SUBJECT: ARKANSAS NUCLEAR ONE, UNIT 2 - ISSUANCE OF AMENDMENT RE:
UPDATING THE REACTOR COOLANT SYSTEM PRESSURE-TEMPERATURE
LIMITS (EPID L-2017-LLA-0396)

Amendment No. 311
Renewed License No. NPF-6

SAFETY EVALUATION BY THE OFFICE OF NUCLEAR REACTOR REGULATION

ARKANSAS NUCLEAR ONE, UNIT 2

Figure 3.4-2A

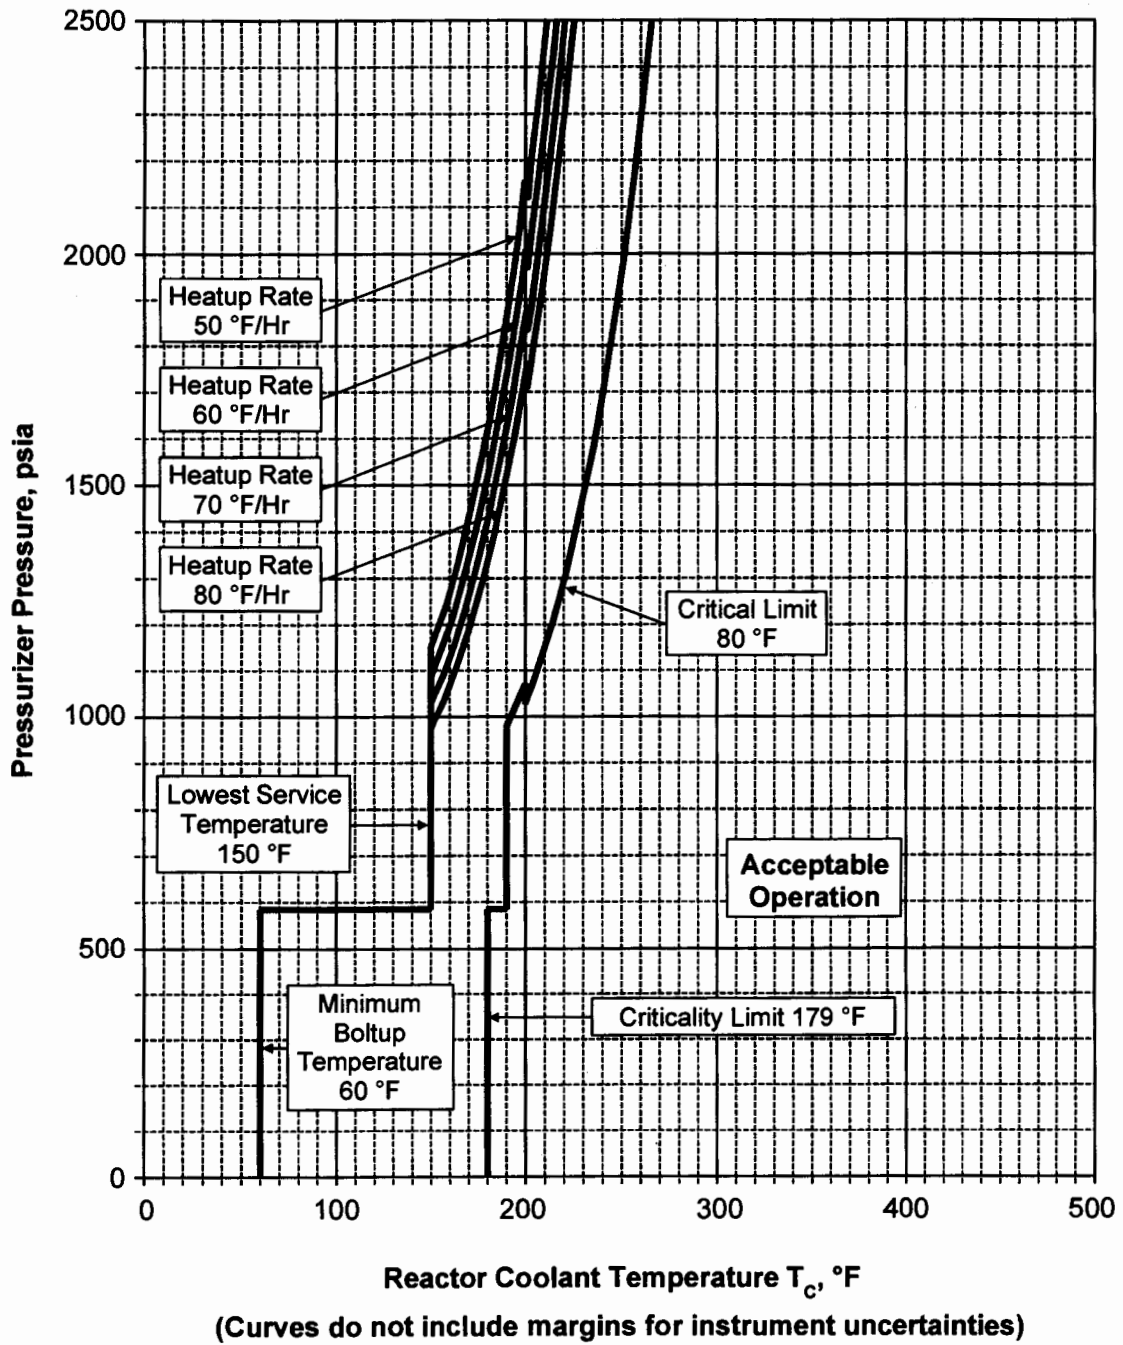
- Replace current Figure 3.4-2A, "HEATUP CURVE – 32 EFPY," with a new figure applicable to 54 EFPY.
- Replace current Figure 3.4-2B, "COOLDOWN CURVE – 32 EFPY," with a new figure applicable to 54 EFPY.
- Replace current Figure 3.4-2C, "INSERVICE HYDROSTATIC TEST CURVE – 32 EFPY," with a new figure applicable to 54 EFPY.

A comparison of the results of the LTOP transient reanalysis discussed in the above Subsections 3.2.1.1 and 3.2.1.2 of this safety evaluation (SE) showed that the peak pressure of 498 psia from the reanalysis of the limiting mass addition event was the maximum peak transient pressure at the pressurizer for the LTOP conditions. A pressure drop in the pressurizer surge line of 2.2 pounds per square inch was added to the LTOP transient peak pressure of 498 psia prior to addressing the compliance of the calculated peak transient pressure with the P-T limits. As shown in TS Figures 3.4-2A and 3.4-2B, the limiting P-T points were 588 psia at 60 °F for the heatup curve and 543 psia at 60 °F for the cooldown curve, respectively.

Since the LTOP transient peak pressure of 500.2 (498 plus 2.2) psia was within both the limiting P-T values of 588 psia for the heatup curve and 543 psia for the cooldown curve, the NRC staff determined that the proposed P-T limits were adequately supported by the LTOP transient reanalysis in meeting GDC 15 as it is related to the requirements of the reactor coolant pressure boundary, and BTP 5-2 as it is related to the guidance of over pressurization protection of PWRs while operating at low temperatures. Therefore, the NRC staff concludes that the P-T limits in TS Figures 3.4-2A and 3.4-2B are acceptable.

- (1) The licensee's proposed 54 EFPY TS P-T limit curves in TS Figures 3.4-2A, 3.4-2B, and 3.4-2C meet the criteria of the ASME Code, Section XI, Appendix G, and are in compliance with the fracture toughness requirements of 10 CFR 50.60 and 10 CFR Part 50, Appendix G through 54 EFPY.
